UK-2152-21 ADDENDUM # 1 04/05/2021

UK-2152-21 Stadium View Stream Restoration

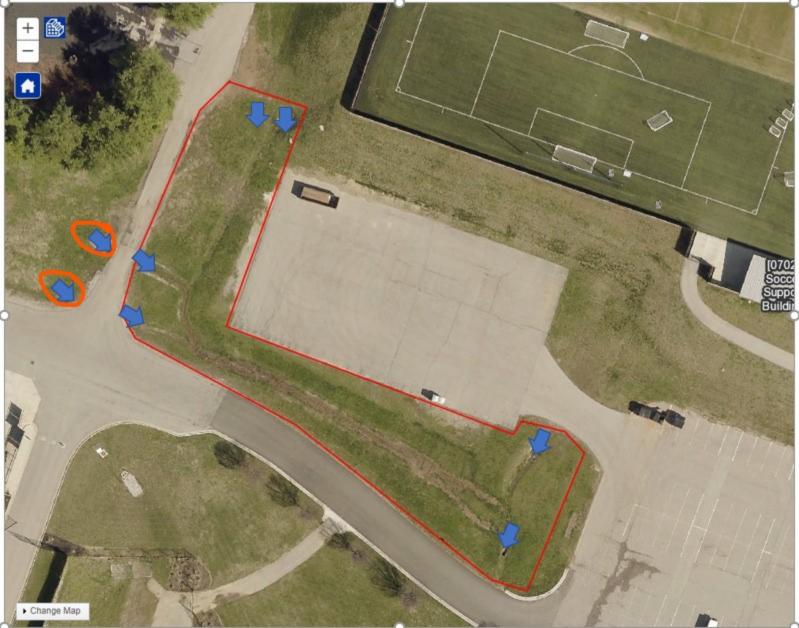
| No. | Question | Answer |
|-----|--|--|
| 4. | In item 2.1 the RFP states that some work will be done to improve the utility and appearance of up to eight headwalls. The figure showing the work area in item 7.3 does not include two on the northwest side of Wildcat Ct. Should we assume these are included? | Yes, please include the two at the northwest side of the road. See attached updated drawing. |
